## NON-CONCURRENCE PROCESS

TITLE OF DOCUMENT <b>Confirmatory Action Letter - Oconee Commitments to Address External Flooding Concerns</b>		ADAMS ACCESSION NO. <b>ML103280043</b>
DOCUMENT SPONSOR <b>Meena Khanna / George Wilson (NRR/DE)</b>		SPONSOR PHONE NO. <b>301-415-2150</b>
NAME OF NON-CONCURRING INDIVIDUAL <b>Jeff Mitman</b>		PHONE NO. <b>301-415-2843</b>

**STAFF RESPONSE TO NON-CONCURRENCE ON THE INITIAL STARTING RESERVOIR  
LEVEL OF THE JOCASSEE DAM FOR THE FLOODING INUNDATION STUDY OF THE  
OCONEE NUCLEAR SITE FOR DEMONSTRATING REASONABLE ASSURANCE**

Figure 1: Jocassee Spillway

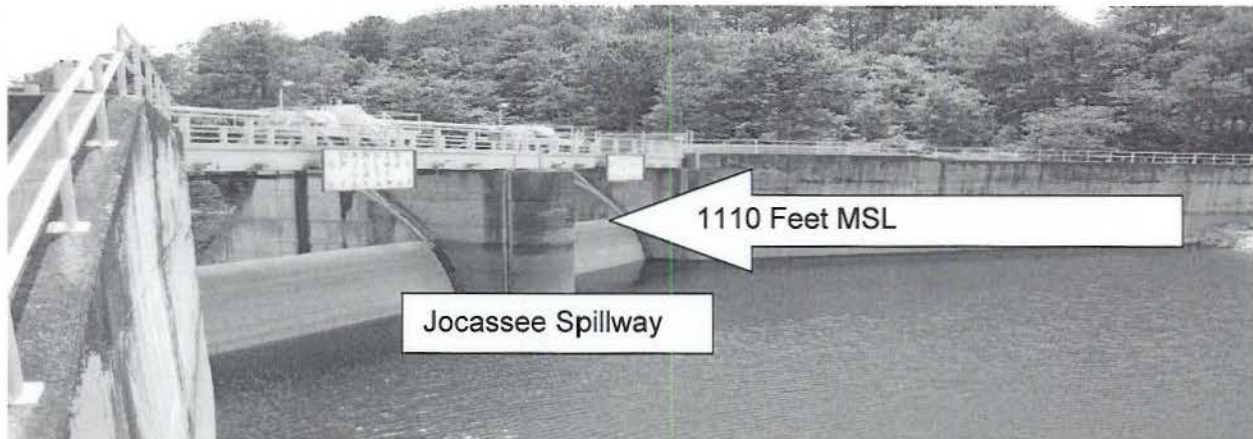
FERC has stipulated the normal operating range of the Jocassee Reservoir as 1080 to 1110 ft msl. The Keowee Reservoir has a normal operating range from 794 to 800 ft msl. FERC also approved the random sunny day failure analysis at a starting reservoir of 1108 ft msl for the Jocassee Reservoir in the 1992 FERC Study performed by Duke Energy. The same rationale applies for the Keowee Reservoir level for being below the top of the operating band. Duke Hydro operates the dams in accordance with the "Keowee - Toxaway Project High-Water Operations Process" procedure. The procedure covers normal and contingency actions for the operation of the dams, specifically the control of the reservoir levels. The contingency actions include lowering the reservoir levels for abnormal rises in lake level and any anticipated significant precipitation. The normal operating pool level of the Jocassee Dam Reservoir is 1108 ft msl, which is 2 ft below the top of the two spillway flood gates, which are at an elevation of 1110 ft msl. Any water level above this elevation would flow over the top of the two spillway flood gates (see figure below). In addition, the maximum allowable operating level during the hurricane season is reduced to 1108 feet msl, to account for any unanticipated sudden heavy

rainfall. This would be the same rationale for the Keowee Dam except it has four gated spillways at 800 ft msl.
